Development Permit Panel Electronic Meeting

- GENERAL COMPLIANCE - REQUEST BY KADIUM NO. 4 DEVELOPMENT LTD. FOR A GENERAL COMPLIANCE RULING AT 10380 NO. 4 ROAD**
(File Ref. No.: DP 21-936427) (REDMS No. 7778537)

That the attached plans involving changes to the proposed Landscape Plan, Tree Management Plan and Landscape Detail Plan, be considered to be in General Compliance with the approved Development Permit (DP 21-936427).

Jason Liang, on behalf of Kadium No. 4 Development Ltd. (Incorporation number: BC1157491), has requested a General Compliance (GC) ruling to modify the Landscape Plan, Tree Management Plan and Landscape Details issued with the Development Permit (DP) (DP 21-936427) at 10380 No. 4 Road.

**TREE MANAGEMENT
PLAN**

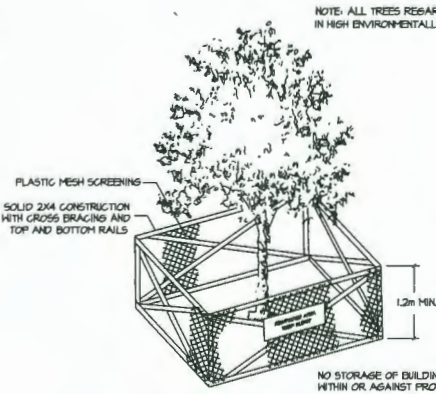
- Consistent with the approved DP, prior to demolition, tree #435 was transplanted by Maple Leaf Tree Movers in July of 2022, to an offsite tree farm facility.

- The transplant was completed as per the specifications of the British Columbia Landscape and Nursery Association (BCLNA). However, the transplant was not successful and tree #435 died post transplant at the tree farm facility.

- The City's Tree Preservation staff have reviewed the submitted documentation from the project arborist in conjunction with records from the transplant contractor. Staff confirmed that the tree died despite the applicant's adherence to best practices.

- To account for the unsuccessful transplant of Tree #435 the applicant proposes to replace Tree #435 with one large tree on-site, a 10cm Dawyck Purple beech, in the same location fronting No. 3 Road as visible in the revised Landscape Plans (Attachment 5 and 6). The City's Tree Preservation Staff have reviewed and approve of this replacement.

9 5'-0" HEIGHT WOOD FENCE
1/2" = 1'-0"

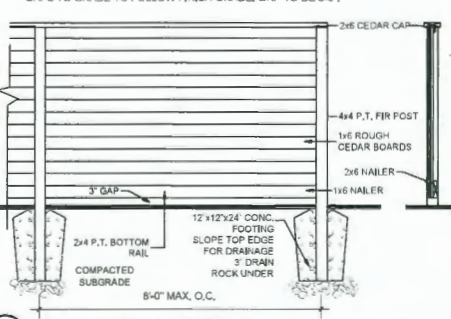
- The applicant received a request from the neighbour to the north to increase the height of the fence to provide additional privacy.
- Staff have no objections to the proposed fence height increase from 1.2m to 1.5m (4 ft. to 5 ft.) which remain consistent with the Zoning Bylaw. The fence material and design remain otherwise unchanged. This change only impacts the fence on the northern property line and no other design changes are proposed.

7 TIMBER RETAINING WALL ON GRADE AND STAIRS
1/2" = 1'-0"

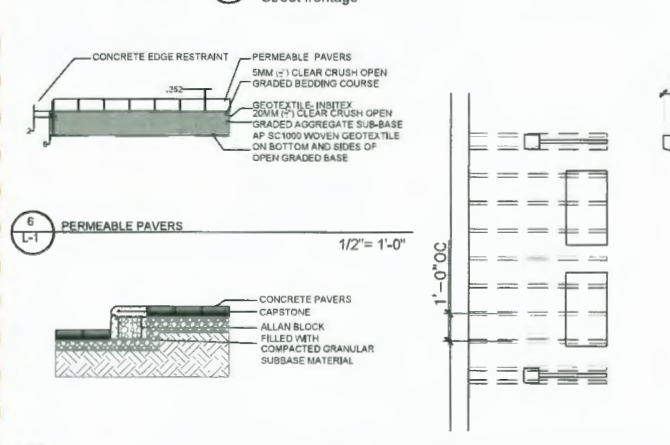
- The applicant has requested to replace the approved Allen Block retaining wall with .5m timber retaining wall to provide a smaller footprint and additional open space next to the existing SRW.
- The proposed changes are visible in the Landscape Details drawing (Attachment 7).
